**PROPOSED REVISIONS TO TECHNICAL SPECIFICATION CHANGES ASSOCIATED WITH
PRESSURE-TEMPERATURE AND OVERPRESSURE PROTECTION SYSTEM
LIMITS FOR UP TO 13.3 EFFECTIVE FULL POWER YEARS**

NEW YORK POWER AUTHORITY
INDIAN POINT 3 NUCLEAR POWER PLANT
DOCKET NO. 50-286
DPR-64

**SAFETY EVALUATION OF REVISED
PROPOSED TECHNICAL SPECIFICATION CHANGES ASSOCIATED WITH
PRESSURE-TEMPERATURE AND OVERPRESSURE PROTECTION SYSTEM
LIMITS FOR UP TO 13.3 EFFECTIVE FULL POWER YEARS**

**MARK-UP OF REVISED TECHNICAL SPECIFICATION PAGES ASSOCIATED WITH
AMENDMENT REQUEST FOR PROPOSED TECHNICAL SPECIFICATION CHANGES
ASSOCIATED WITH PRESSURE-TEMPERATURE AND OVERPRESSURE PROTECTION
SYSTEM LIMITS FOR UP TO 13.3 EFFECTIVE FULL POWER YEARS**

Figure 3.1.A-5

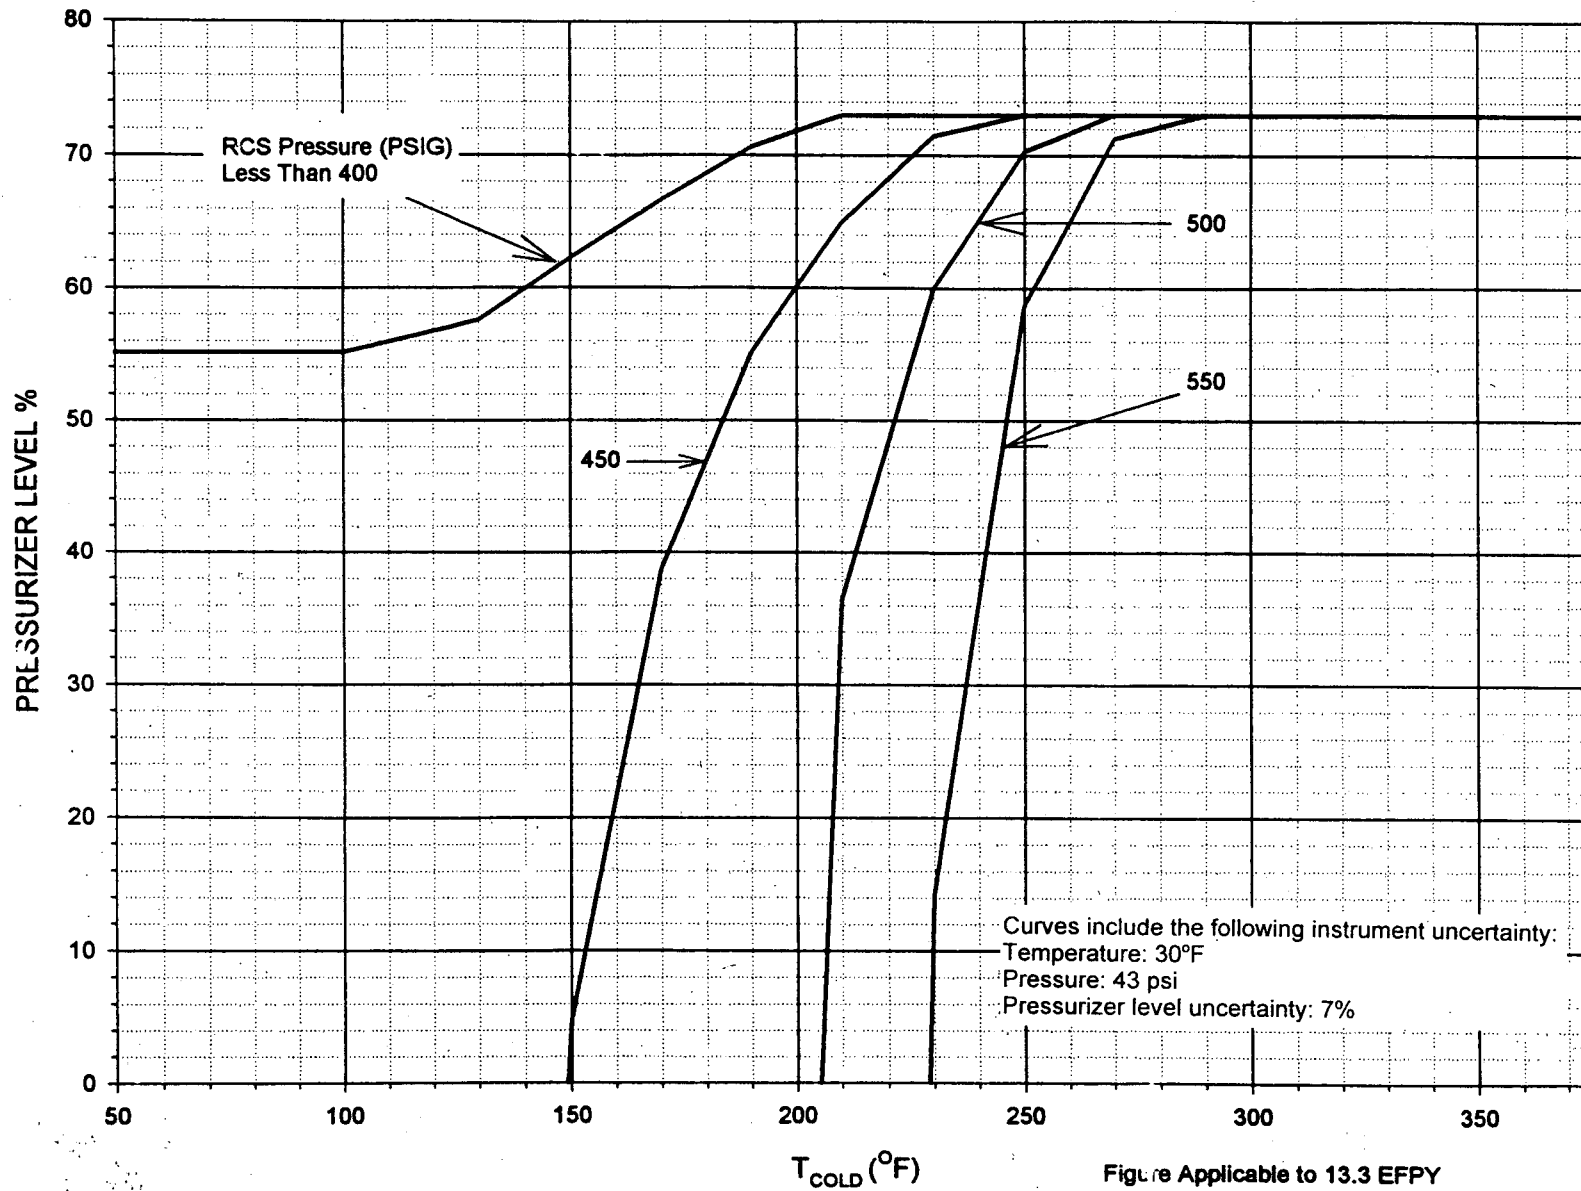
Figure applicable to 11 EFPY

MAXIMUM PRESSURIZER LEVEL WITH OPS INOPERABLE AND
ONE (1) CHARGING PUMP ENERGIZED

Pressurizer Limitations for OPS Inoperable
(Up to one charging pump capable of feeding RCS), 13.3 EFPY

Figure Applicable to 13.3 EFPY

Figure 3.1.A-6

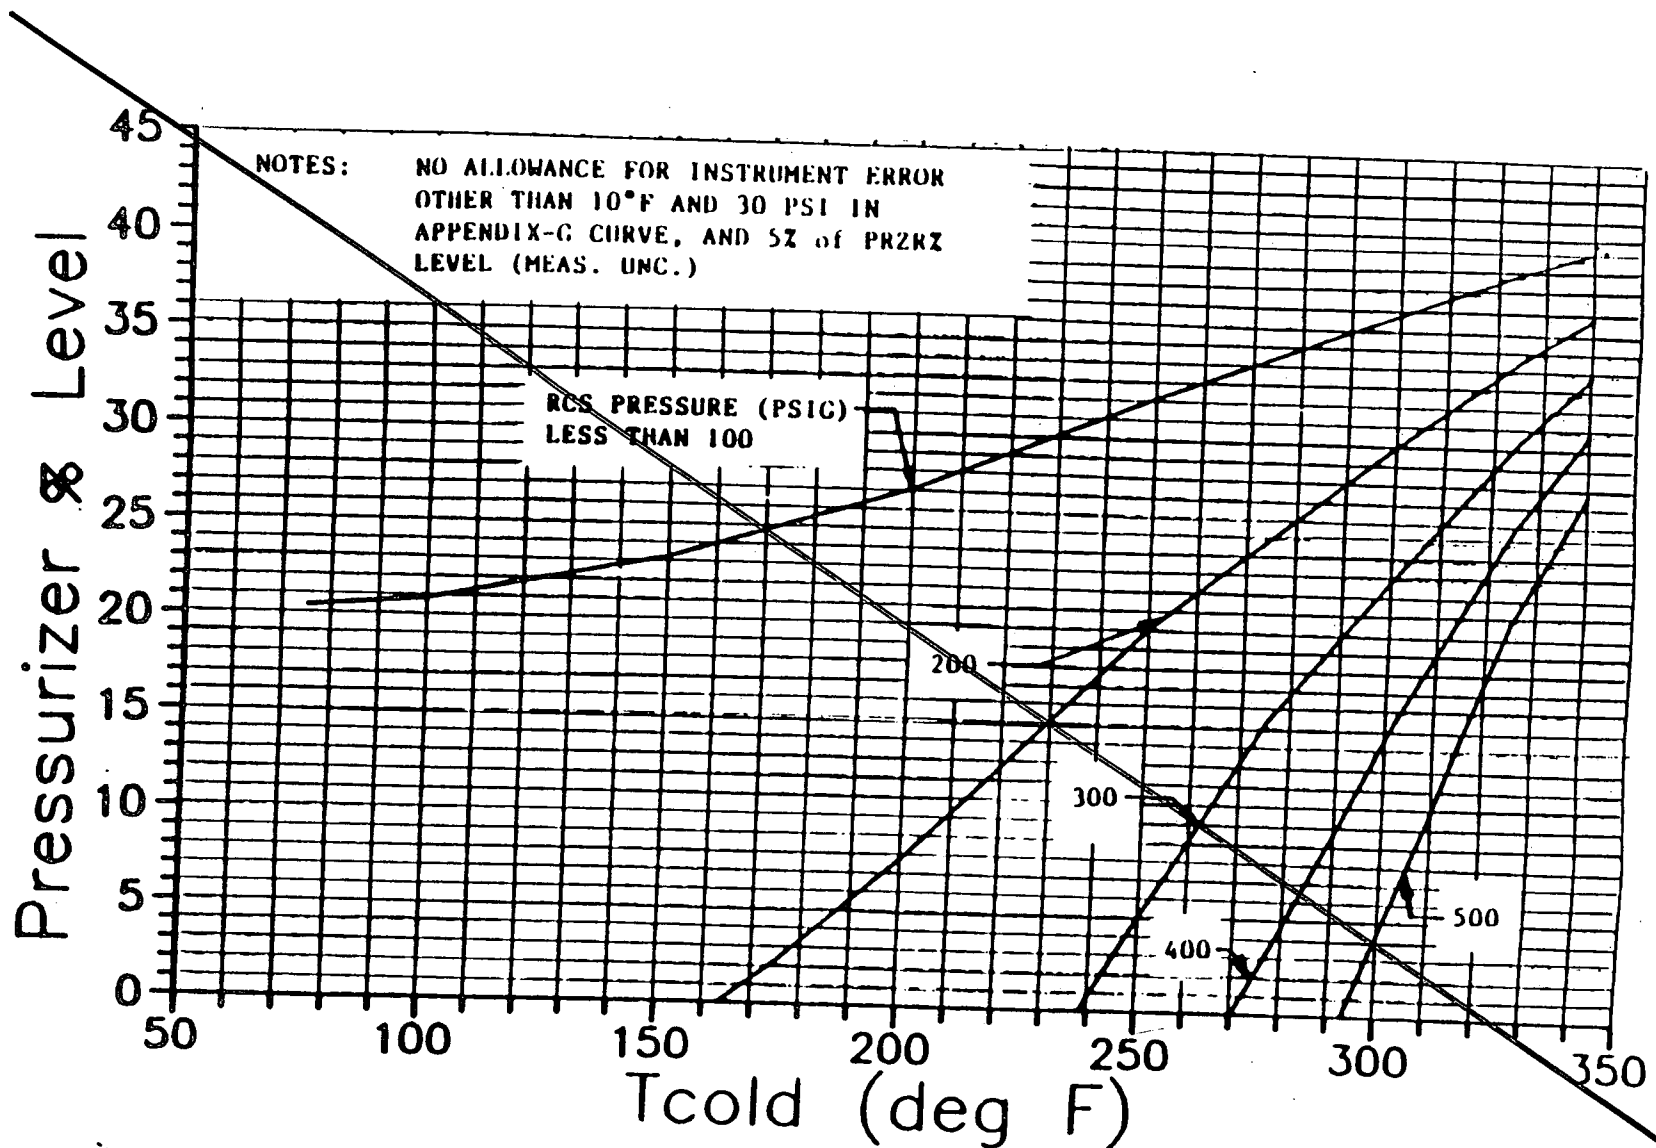
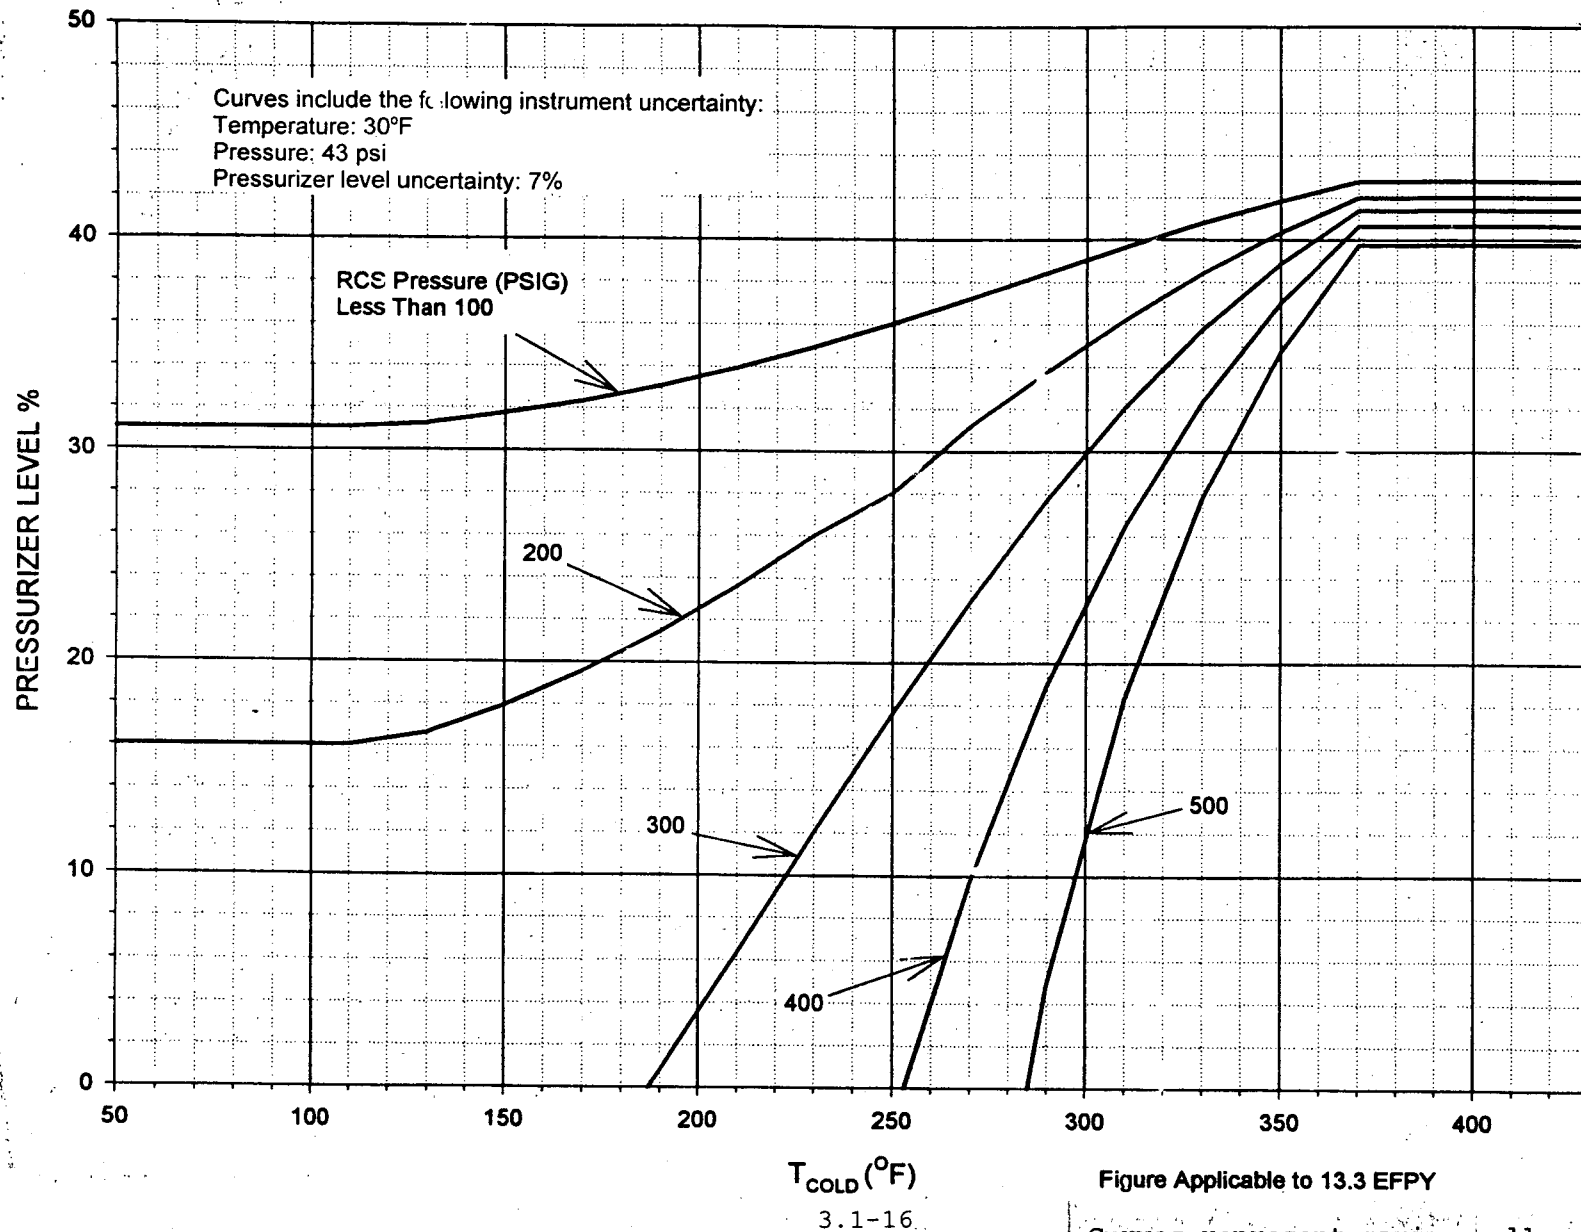
Figure applicable to 11 EFPY

MAXIMUM PRESSURIZER LEVEL WITH OPS INOPERABLE AND ONE (1)
SAFETY INJECTION PUMP AND/OR THREE (3) CHARGING PUMPS ENERGIZED

Pressurizer Limitations for OPS Inoperable (up to three charging pumps and/or one safety injection pump capable of feeding RCS), 13.3 EFPY

FIGURE 3.1-1

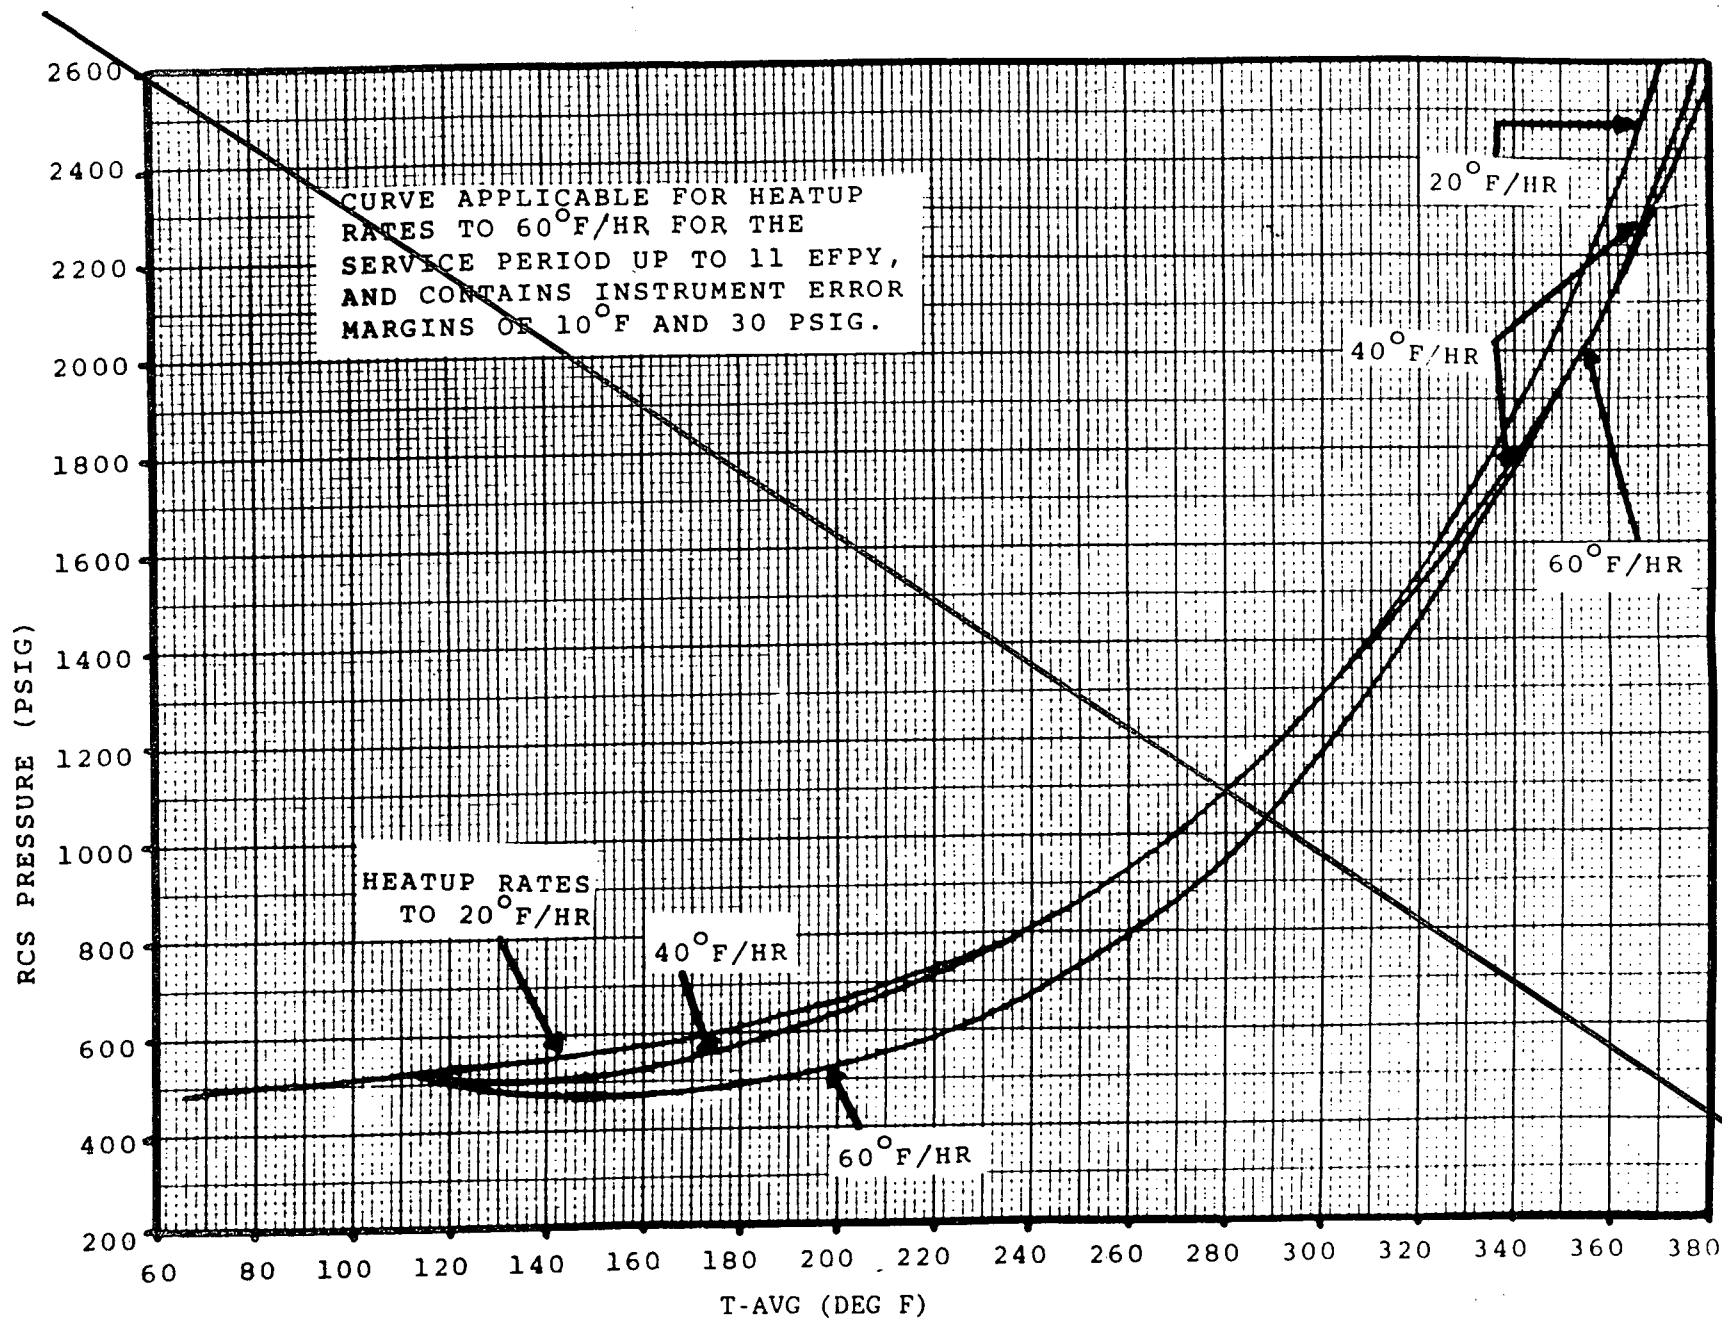
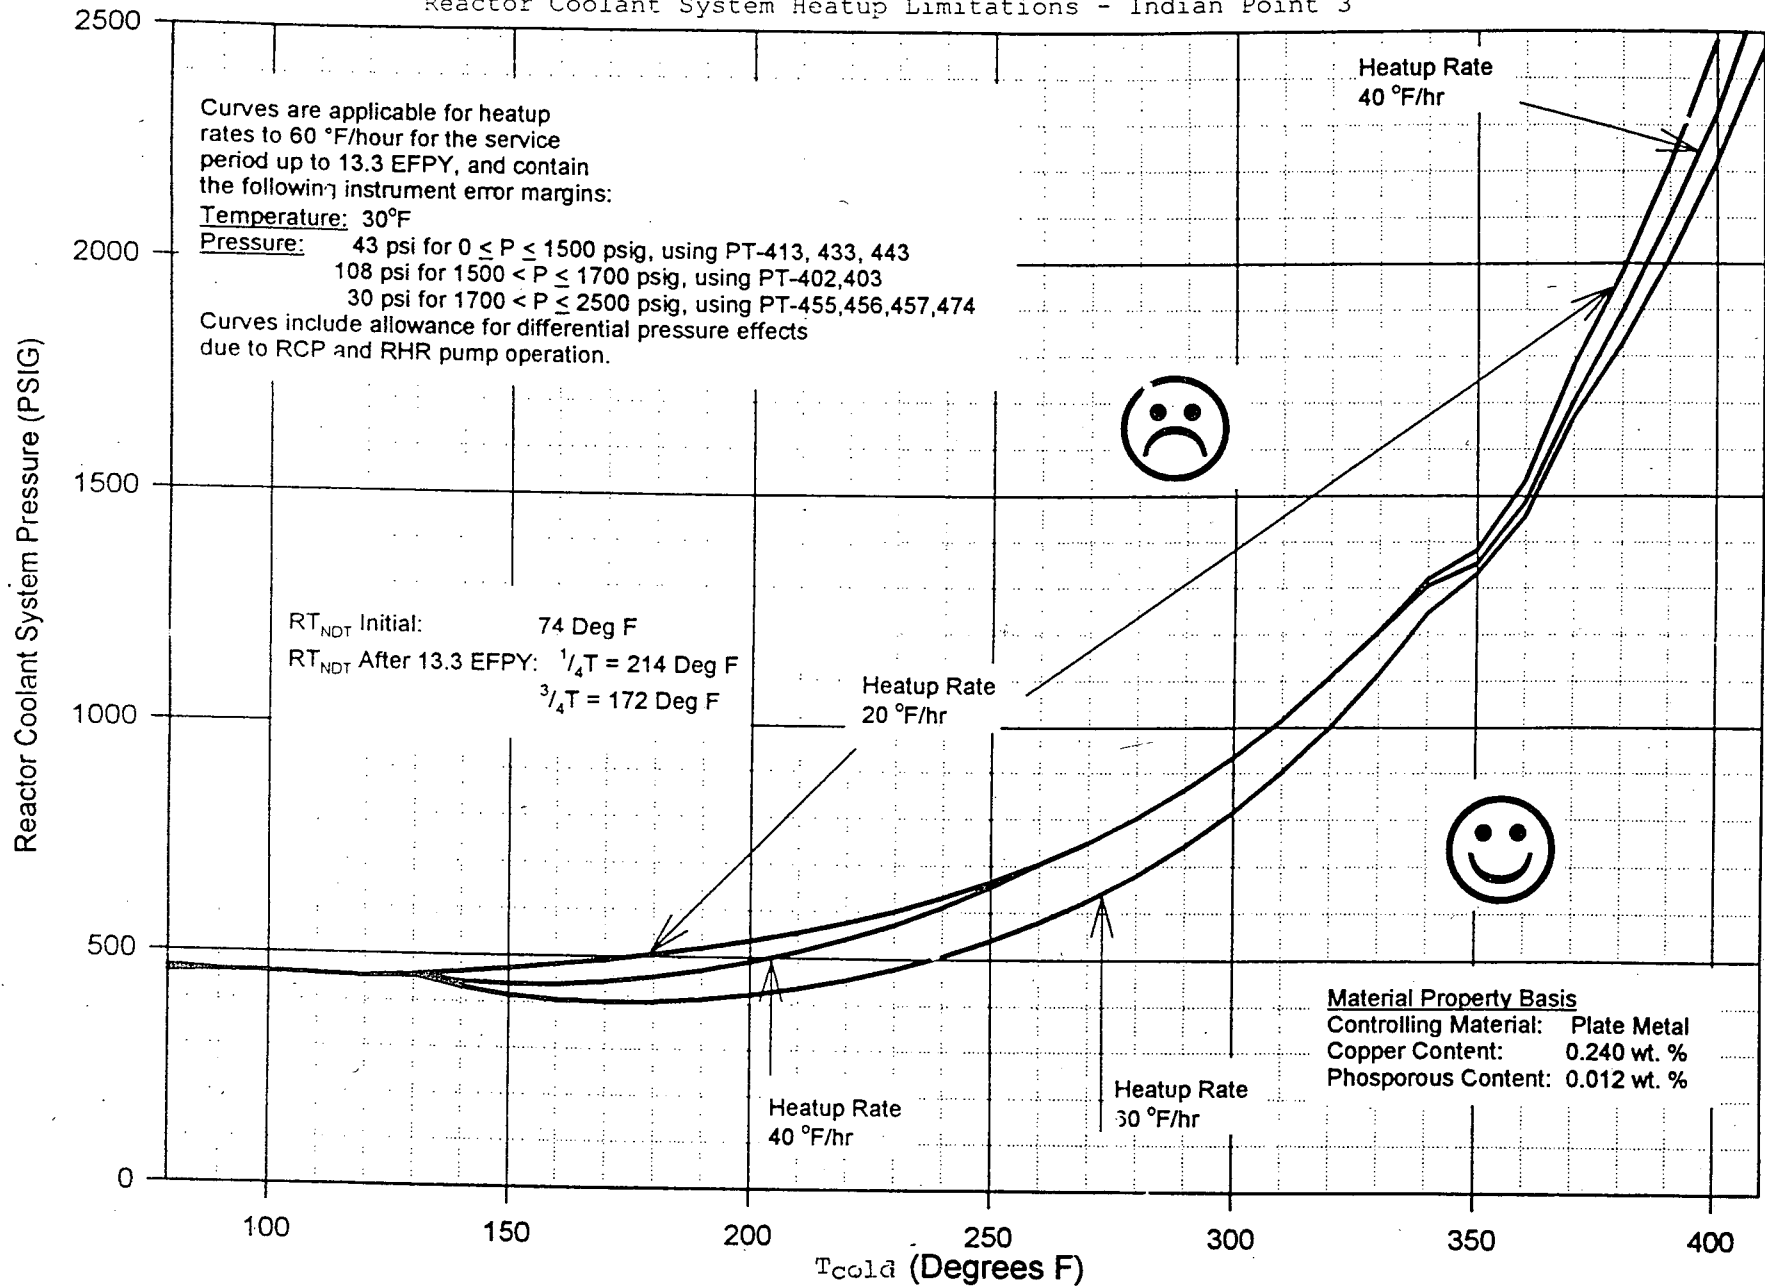
The first reactor vessel material surveillance capsule was removed during the 1978 refueling outage. This capsule has been tested by Westinghouse Corporation and the results have been evaluated and reported ⁽⁷⁾. Similar reports were prepared for the surveillance capsules ^(10, 8) removed in 1982 and 1987. Based on the Westinghouse evaluation, heatup and cooldown curves (Figures 3.1-1 and 3.1-2) were developed for up to ~~11.00~~ 13.3 EFPYs of reactor operation.

The maximum ~~shift value~~ in RT_{NDT} after ~~11.00~~ 13.3 EFPYs of operation is projected to be ~~202°F~~ 214°F at the 1/4 T and ~~163°F~~ 172°F at the 3/4 T vessel wall locations for Plate B2803-3 the controlling plate. Plate B2803-3 was also the controlling plate for the operating period up to ~~9.00~~ 11 EFPYs.

Reactor Coolant System Heatup Limitations - Indian Point 3
